Australian Air Publication 721.79

ROYAL AUSTRALIAN AIR FORCE

VAMPIRE MODIFICATIONS

(Nos 401 to 500)

DEPARTMENT OF AIR ISSUED BY SENIOR TECHNICAL STAFF OFFICER SUPPORT COMMAND			TITLE LOCK NUT	
DRAWN H WOLFE	CHECKED 	APPROVED 	MODIFICATION NUMBER VAMPIRE MOD 451	DRAWING NUMBER DA 66217001

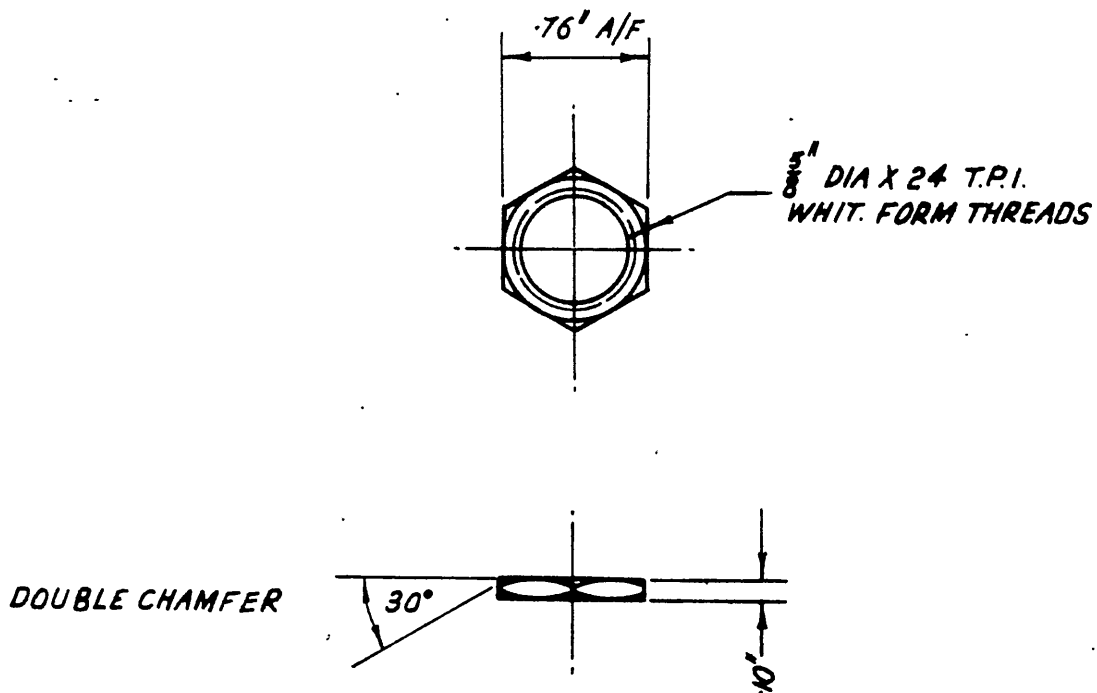
- 12.
- (a) Manufacture lock nuts (2 off) in accordance with Drawing No DA66217000 using item 1.
 - (b) Open the nose cap and disconnect the aircraft batteries.
 - (c) In the main undercarriage wheel wells remove the two access panels situated on the rear walls.
 - (d) Open the lower inspection door to gain access to the engine bay.
 - (e) Locate the existing junction boxes through the panels in the wheel wells and disconnect the connector from the engine bay and undo all ties.
 - (f) Working from the engine bay, pull the disconnected connector back along the conduit until the wing break joint becomes visible at the engine bay end.
 - (g) Undo the joint and remove the straight connector.
 - (h) Obtain completely threaded connector with lock nuts and couple up both ends of the existing pacitor cable finger tight and lock with spanners on centre lock nuts.

MATERIAL :- BRASS HEX. TO B.S.B. 11 (E) D703 IDENT. 11/8035
 ALTERNATIVE :- B.S. 251 AS H3 IDENT. 11/817
FINISH :- CAD. PLATE TO D.T.D. 904 C

DEPARTMENT OF AIR ISSUED BY SENIOR TECHNICAL STAFF OFFICER SUPPORT COMMAND			TITLE REPOSITIONING OF DOWNWARD IDENT LIGHT CONNECTOR	
DRAWN MIF	CHECKED <i>[Signature]</i>	APPROVED <i>[Signature]</i>	MODIFICATION NUMBER VAMPIRE MOD N° 450	DRAWING NUMBER DAG66 212000

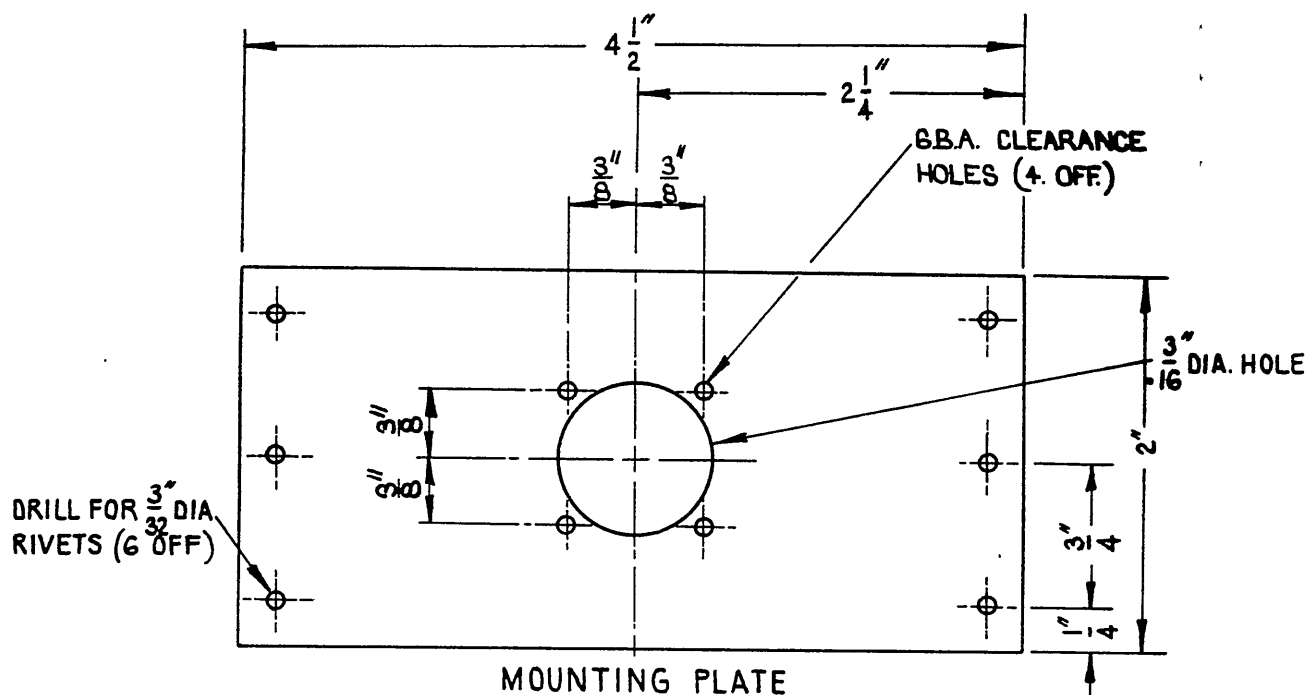
12. (a) Isolate electrical power from the aircraft and refer to attached drawing for the following operations.
- (b) Using item 1, manufacture mounting plate to dimensions, hole locations and hole sizes as shown.
- (c) Using plate as template, position across lightening hole in front former of rear tail cone, drill mounting holes and rivet plate in position, using item 2.
- (d) Reposition the downward ident light connector plug on mounting plate using existing mounting hardware.

SECURE MOUNTING
PLATE WITH $\frac{3}{32}$ " DIA. UNI. HD.
AL. ALLOY RIVETS X $\frac{3}{16}$ " - 6 REQ'D
(IDENT N° 5320-117-6814)

Attachment: Drawing No DA66123000

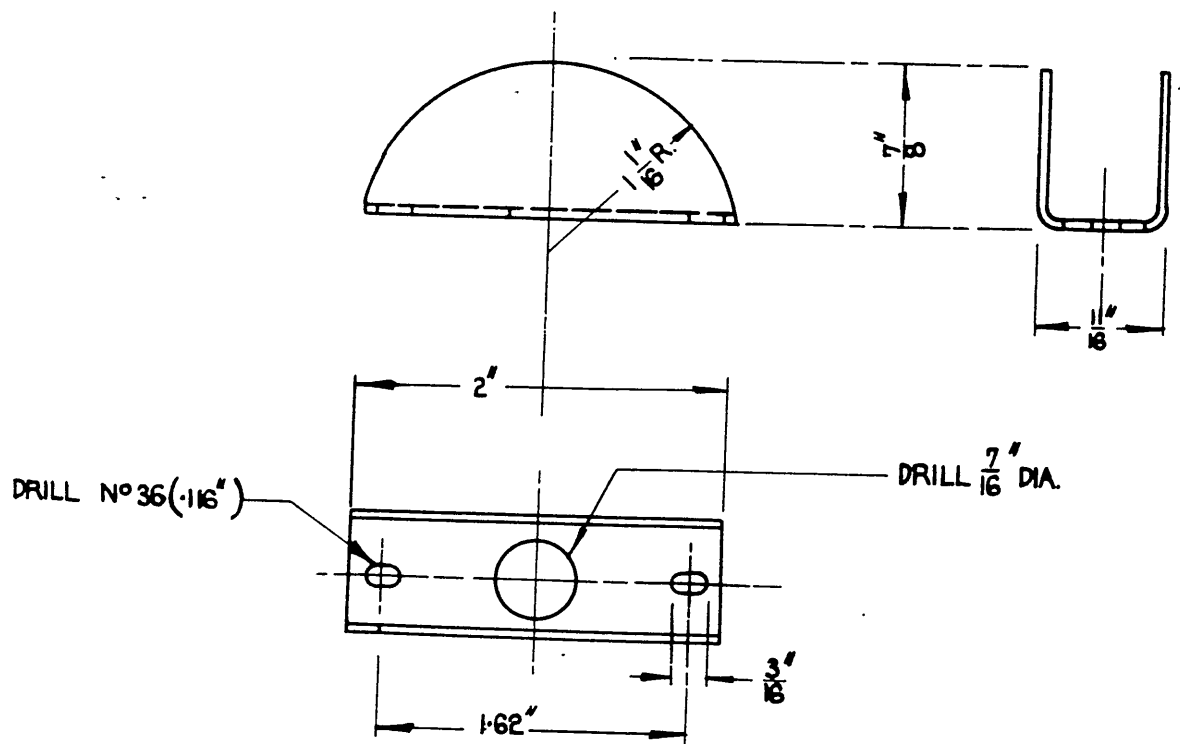
12. (a) Using item 1, manufacture guard in accordance with attached drawing. Finish matt black.
- (b) At top left hand side of centre instrument panel shroud, remove and retain the emergency light switch mounting screws.
- (c) Fit manufactured guard over switch toggle and secure with the mounting screws retained above.

MATERIAL : .048" ALUM. ALLOY SHEET
 SPEC : QQ - A - 362 T3
 FINISH : ZINC CHROMATE. PAINT MATT BLACK.

REINFORCEMENT OF WINDSCREEN
ARCH MEMBER AND SIDE CASTINGS.

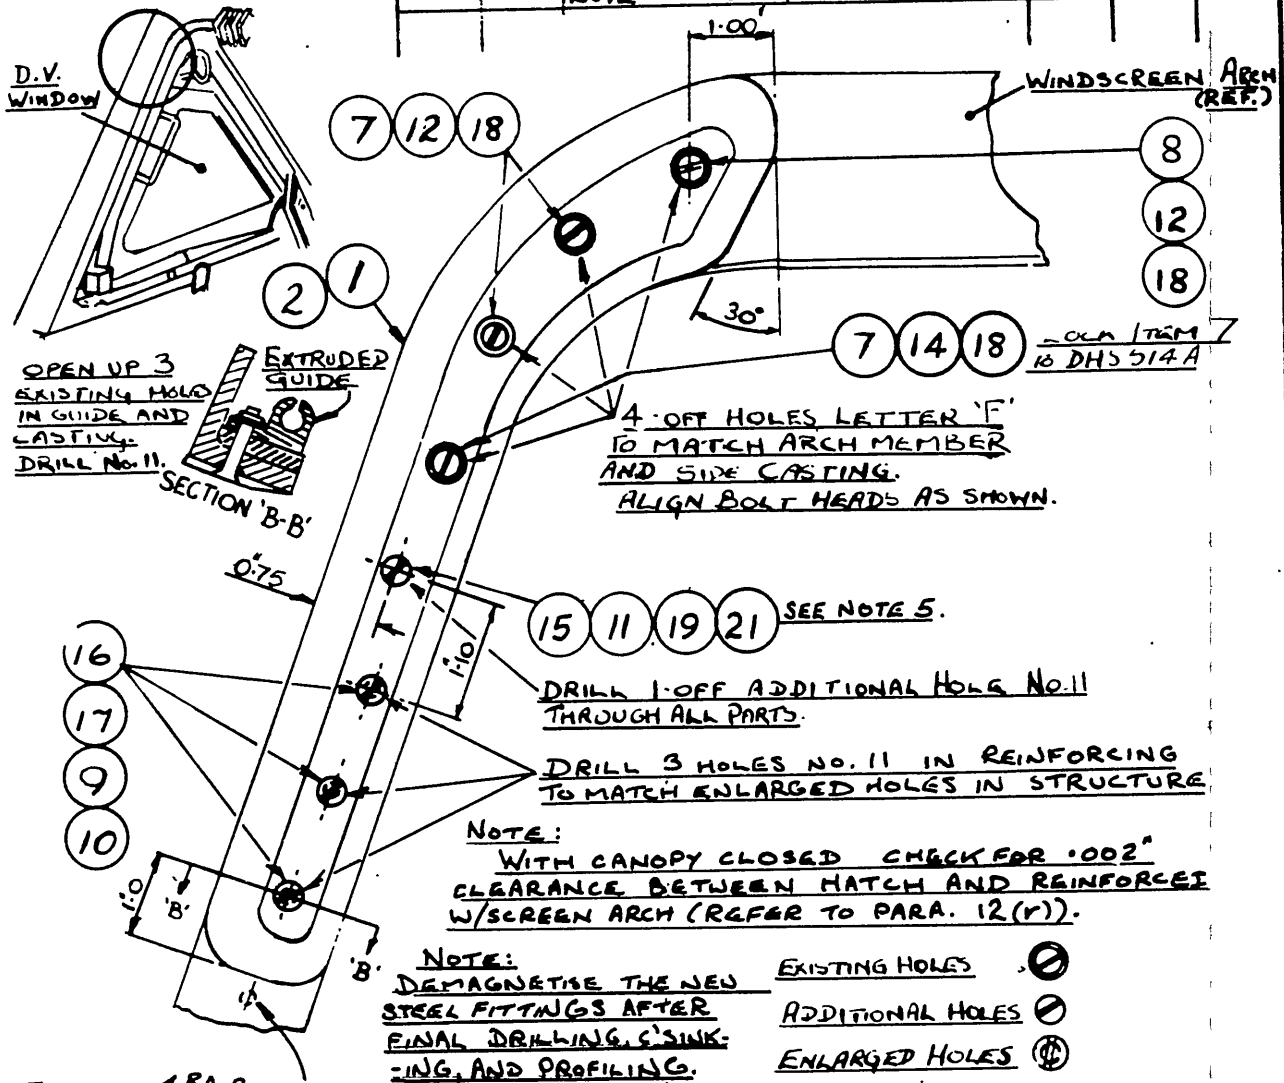
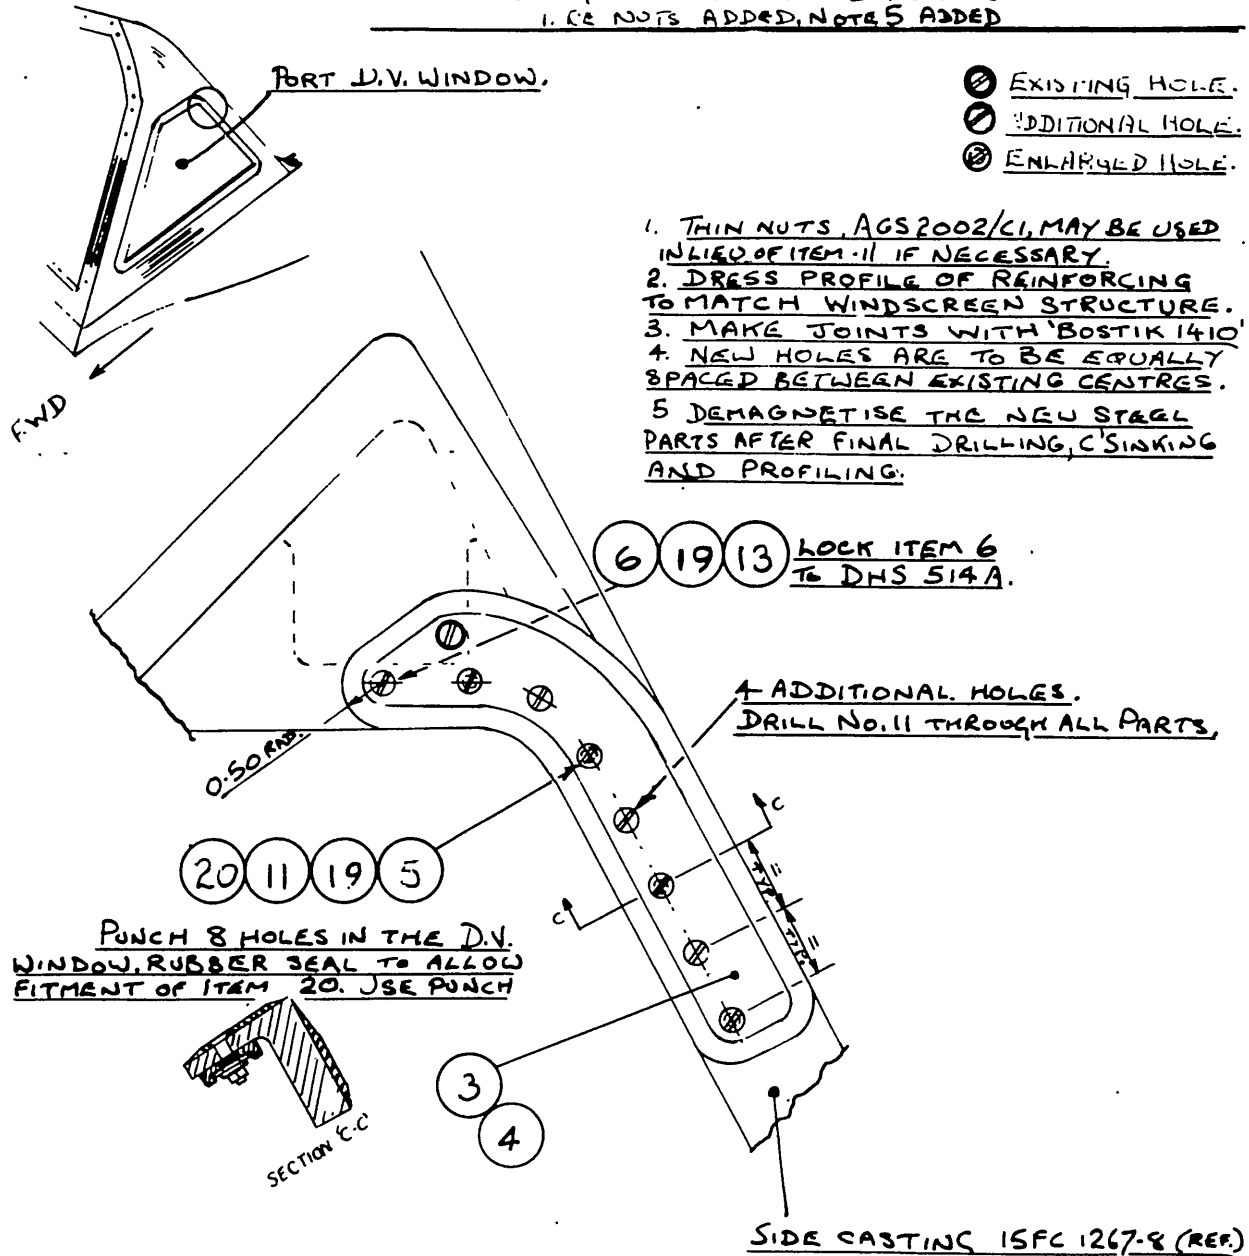
- (b) Refer to Drawing No A15891 sheet 1. From the aft face of the windscreen side casting, remove the four 4BA bolts securing the extruded guide Part No 15FC-2933 (ref), retaining only one bolt.

- (k) Coat all mating faces with "Bostik 1410", then secure all items in position with their attachments as shown on sheet 1 of the drawing. Remove the surplus threads of the top five bolts where necessary ensuring that the bolt heads are flush and that the slots are aligned as shown. Secure the retained 4BA bolt in the lowest hole of the side casting and extruded guide.

- (m) Refer to sheet 2 of the drawing. Remove one 2BA and four 6BA redundant bolts, nuts and washers from the positions shown in the side casting. The four 6BA holes are to be re-drilled No 11.

- (p) Fill the countersunk area of the top existing hole in the side casting with "Hermetal" filler (item 24).
- (q) Coat all mating surfaces with Bostik 1410 (item 22) then secure the reinforcing to the side casting with the attachments shown on sheet 2 of the drawing. Remove surplus threads where necessary.

NOTE:
A FILLET OF
EPAPTOP, EPOXY
RESIN MAY BE
APPLIED BETWEEN
REINFORCING AND
W/SCREEN STRUCTURE
TO REDUCE LOSS OF
COCKPIT PRESSURE.

LOCATION OF VELCRO STRIPS
ON INSTRUMENT PANEL

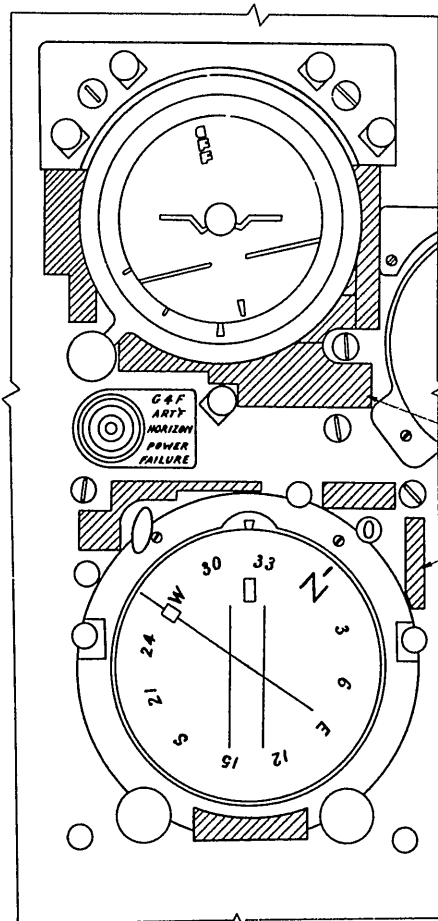
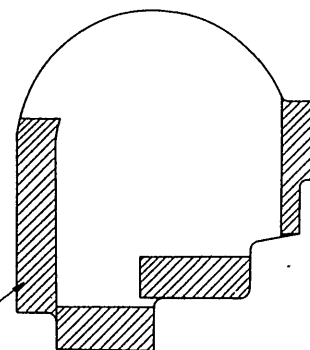
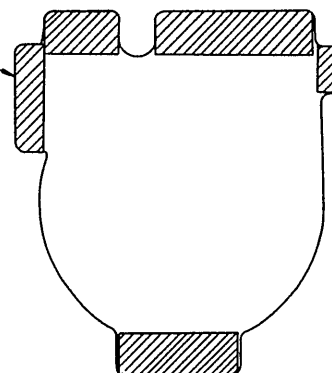
12. (a) Using the hook portion of item 1 attach it to the instrument panel, as detailed in Drawing A15401, with item 5 adhesive.
- Note: Apply a minimum amount of pliobond to the desired areas and allow them to nearly dry before bringing them together.

- (b) Cut item 2 to the shapes detailed in Drawing A15401, trimming each piece individually to fit the panel over the instruments.
- (c) Using item 5 attach the "wool tuft" portion of item 1 to item 2, as detailed in the drawing.

- (g) Using items 6 to 10, manufacture a stowage bag as detailed in Drawing A15401.
- (h) Using items 11 and 12 attach the stowage bag to the starboard cockpit wall.
